**Corrigendum No.5 along with Informative Replies-2**

**Name of Work: Lot-III: Electro-mechanical works package of 240 MW (2X120MW) Uri-I Stage-II H.E Project, Baramulla District of UT of J&K, India.**

**Ref: Tender Specification No. NH/ NH/ Conts(E&M)-III/ Uri-I Stage-II/ ENM/ 2025/ 01**

Technical\_D\_Amendment\_02

POWER HOUSE AREA  
TAIL RACE SURGE GALLERY  
GENERAL ARRANGEMENT- PLAN

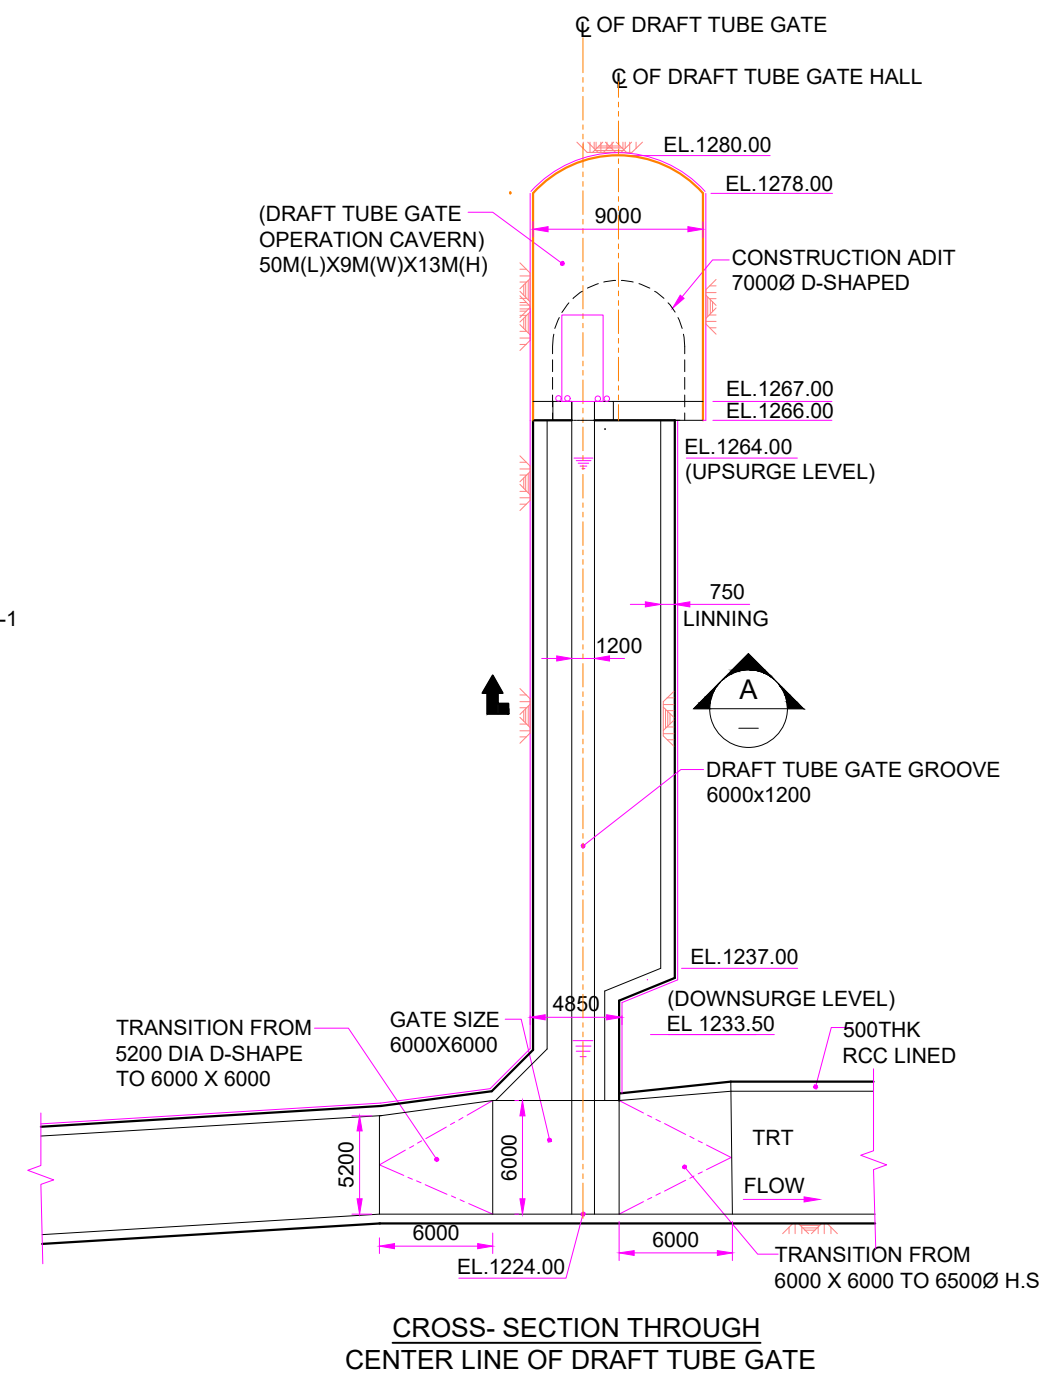
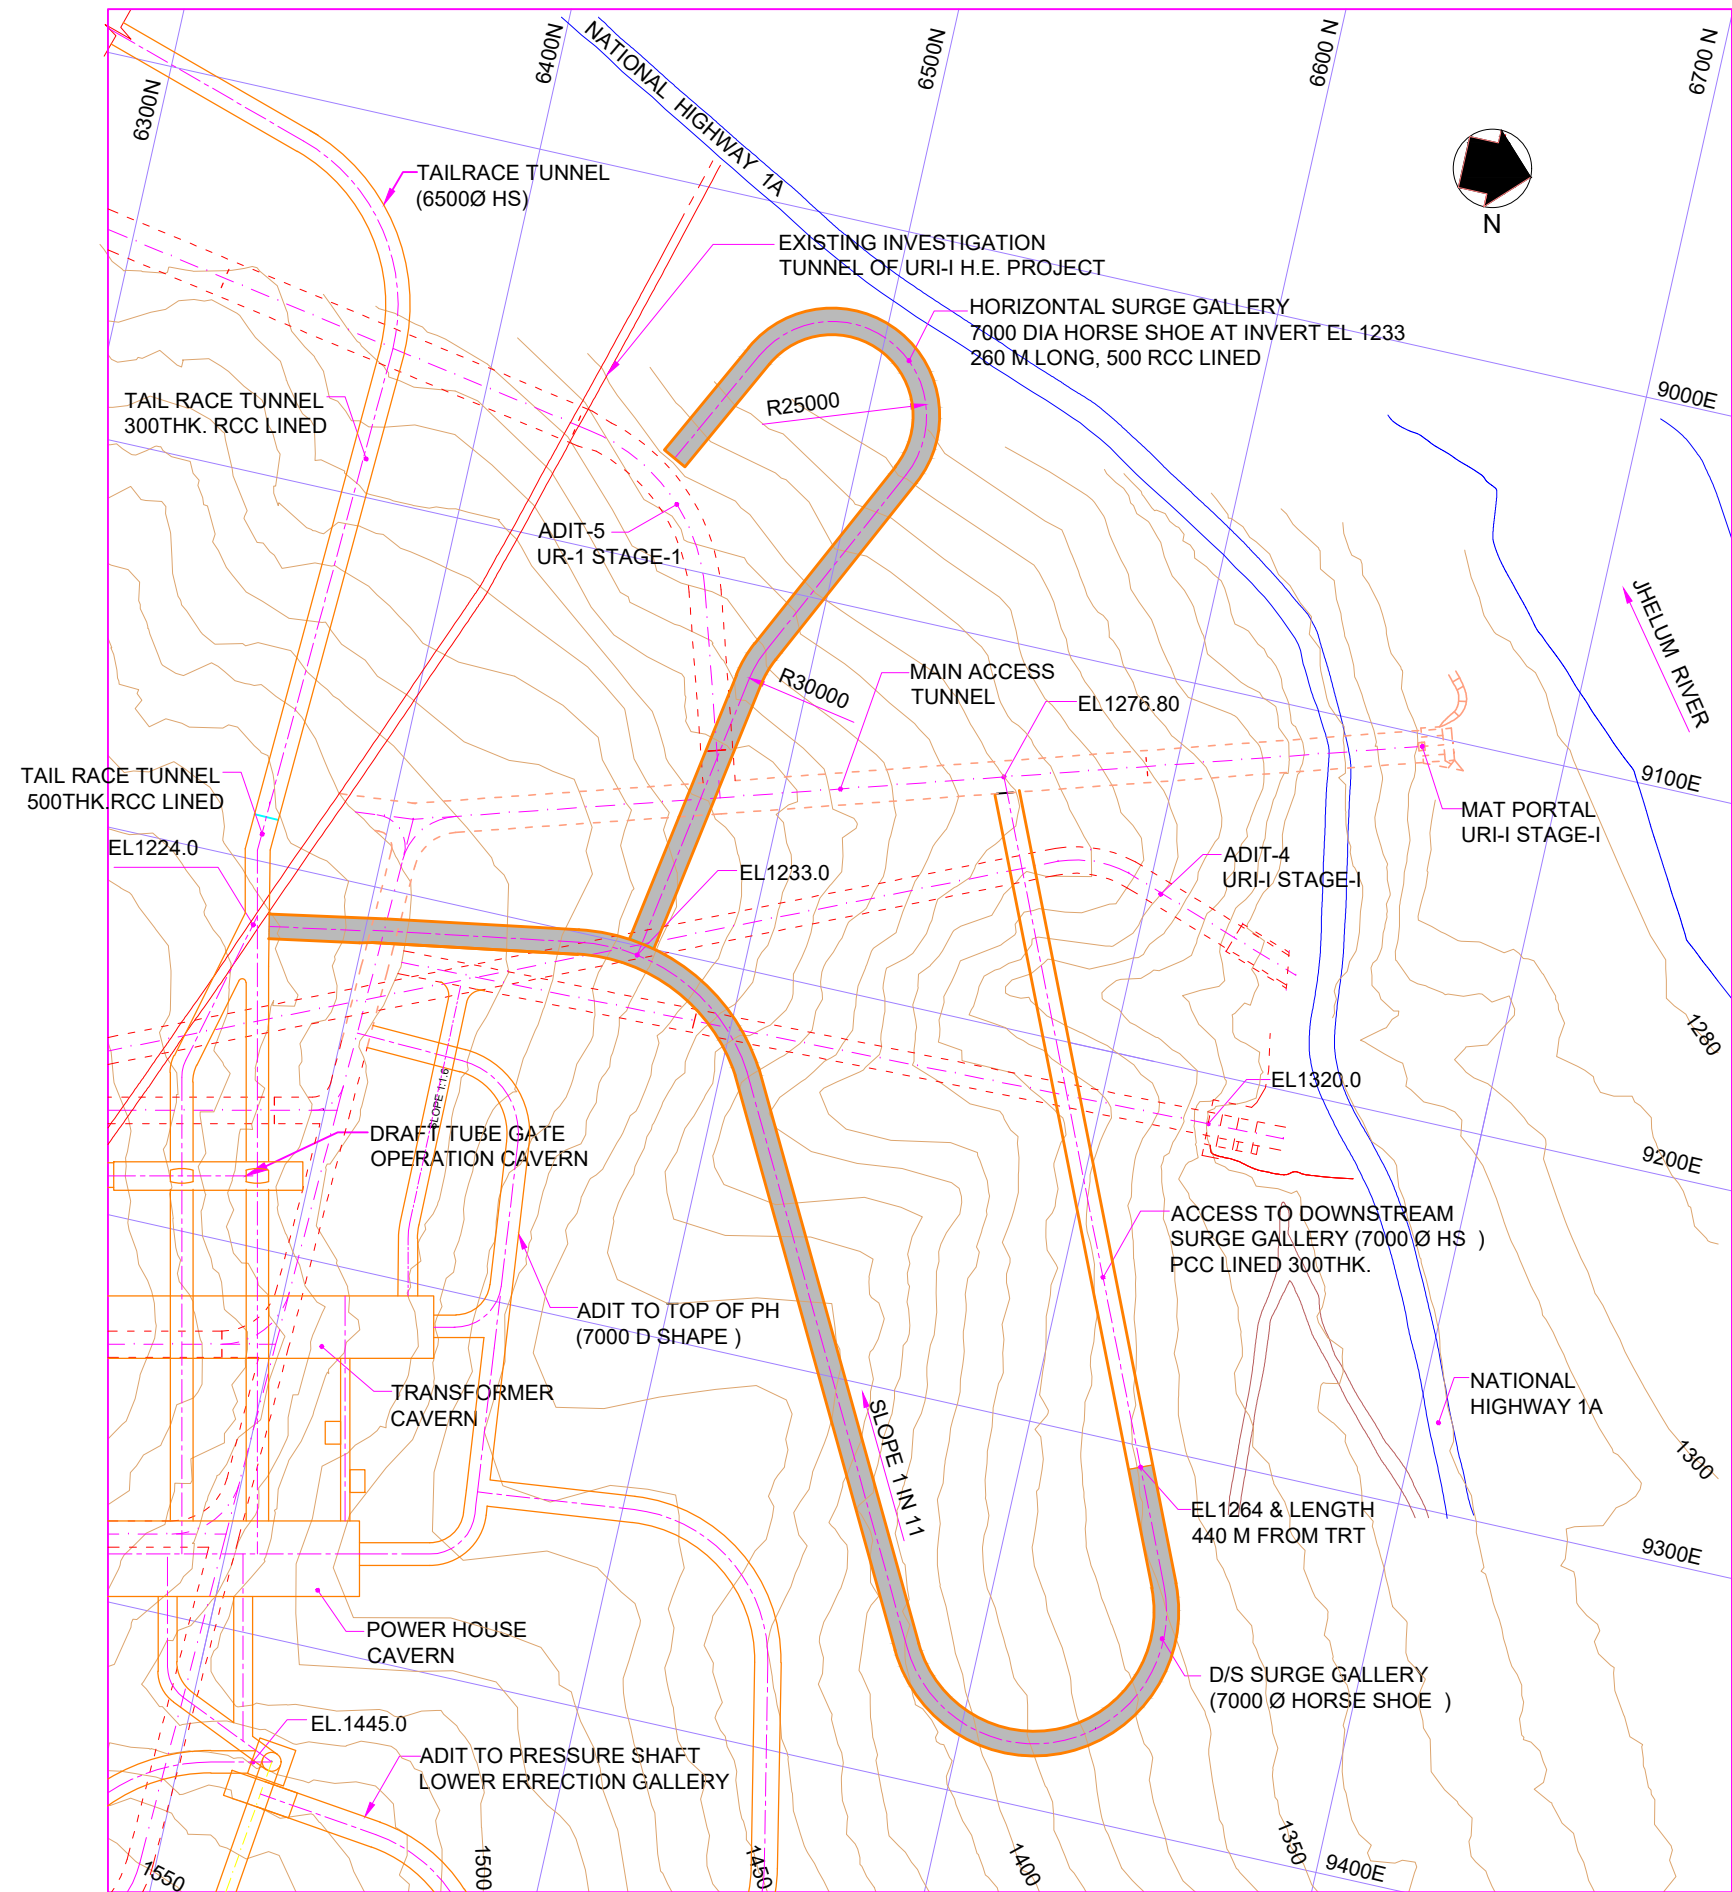
7	General		You have provided some drawings of waterways in corrigendum no 2. However, some drawings are still missing which are required to perform the transient analysis for the project. Kindly request you to arrange to provide the drawing listed below. Kindly share all drawing in AutoCAD format.  •L section of HRT (from Intake to upstream surge tank) • L section/ cross section of Downstream surge gallery.	pdf files of drawings have already been issued vide earlier corrigendum.  Pl refer Annexure-A & B of this informative replies-2

S.No.	Section Chapter/ Clause	Heading	Pre bid question	Reply of NHPC Ltd.
21 of Part-B Informative Replies	Volume-1 Information For Bidder (IFB) / Clause 4 Volume-4 Tender Drawings	Salient Features – Surge Shaft and Surge gallery for downstream water conductor	<p>Please provide below details</p> <ul style="list-style-type: none"> <li>- Surge shaft orifice diameter and orifice loss coefficients. Also Provide cross section drawing showing these details.</li> <li>- Downstream Surge gallery cross-section drawing.</li> </ul> <p>We need above details as the same are Not specified in given Clause and drawings.</p>	<p>During DPR stage Transient conditions have been analysed using the computer programme WHAMO (Water Hammer and Mass Oscillations) developed by US Army corps of Engineers.</p> <p><b>For upstream water conductor system :-</b></p> <p>Restricted orifice type surge shaft has been provided: - the size of surge shaft is 17 m diameter, the encroachment area has been taken as 19.5 m<sup>2</sup> thus net equivalent area is 207.4 m<sup>2</sup>. Orifice area has been taken as 11 m<sup>2</sup>.</p> <p>The orifice loss coefficient, (Cd) during upsurge &amp; down surge are considered as 0.84 &amp; 0.97 respectively in the analysis.</p> <p>The drawings no. NHUR-I(II)-3DT1-41-GA-025-00 of surge shaft is attached for reference .</p> <p><b>For downstream water conductor system :</b></p> <p>The downstream water conductor transient analysis has been carried on WHAMO considering Draft tube having Gate shaft area of 21.1 m<sup>2</sup> up to EL 1237 m &amp; 35.5 m<sup>2</sup> above EL 1237 m for which an opening of 6m x 3.8m below EL. 1237.0m has been provided and an opening of 6.0m x 6.2 m above EL. 1237.0 has been provided.</p> <p>In addition Surge gallery of 7 m ø horse shoe shape &amp; inclined with invert @ EL 1224 m to EL 1264 m in the slope of 1 in 11 and 7 m ø horse shoe shape horizontal gallery of length 260 m with invert @ EL 1233 m has been provided.</p> <p>The drawings no.</p> <p>1) NHUR-I(II)-4AT1-41-GA-004-00 ,</p>

<p>2) NHUR-I(II)-4DT1-41-GA-025-00  3) NHUR-I(II)-4CT1-41-GA-044-00  4) NHUR-I(II)-4CT1-41-GA-069-00,  5) NHUR-I(II)-4DT1-41-GA-076-00  are attached as Annexure-B for reference .</p> <p>However in compliance to techno-economic clearance of the project from CEA, the physical and Mathematical Numerical Hydraulic model studies are being carried out. Based on these studies, the arrangement may be updated during the detailed design stage.</p>
--	--	--	--	---
